TECHNICAL SERVICE BULLETIN

Technical Service Bulletin: 205-1281

TECHNICAL SERVICE BULLETIN 205-1281 REMEDY INSTRUCTIONS

Make(s): CATALINA Model(s): ACAT303QBCKLE Model Year(s): 2021	Repair Code: SB-455-01-00-003969 Allotted Time: .80 HRS. Inspection Code: N/A Allotted Time: N/A
	Concern: The incorrect length spring hangers were installed on the vehicle. This condition may not allow the stabilizing jacks to touch the ground when an operator tries to stabilize the vehicle for use.	Photo(s) Required: YES Prior Authorization Required: YES Part(s) Number: F100245000 Part(s) Return: NO

FRONT JACK

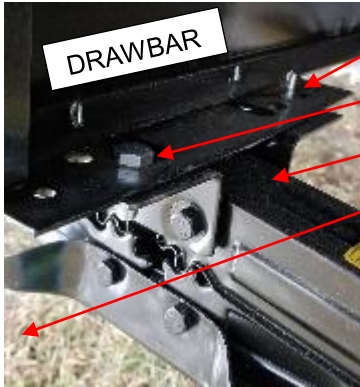
The incorrect length spring hangers were installed on the vehicle. This condition may not allow the stabilizing jacks to touch the ground when an operator tries to stabilize the vehicle for use.

STEP 4: INSTALL THE NEW/REPLACEMENT STABILIZER JACK BY USING THE SAME HOLE(S);

- REPLACE ALL HARDWARE WITH THE PROVIDED NEW HARDWARE;
- TAKE CARE TO NOT STRIP OUT THE THREE SELF TAPPING SCREWS;
- INSTALL THE BOLT USING A FLAT WASHER ON THE BOLT HEAD SIDE, A FLAT WASHER AND LOCK WASHER THEN A NUT ON THE OTHER SIDE AND TORQUE TO CORRECT SPECIFICATION;
- IT IS **REQUIRED** TO HAVE A MINIMUM OF ONE BOLT INSTALLED IN EACH JACK FOR SAFETY REASONS;
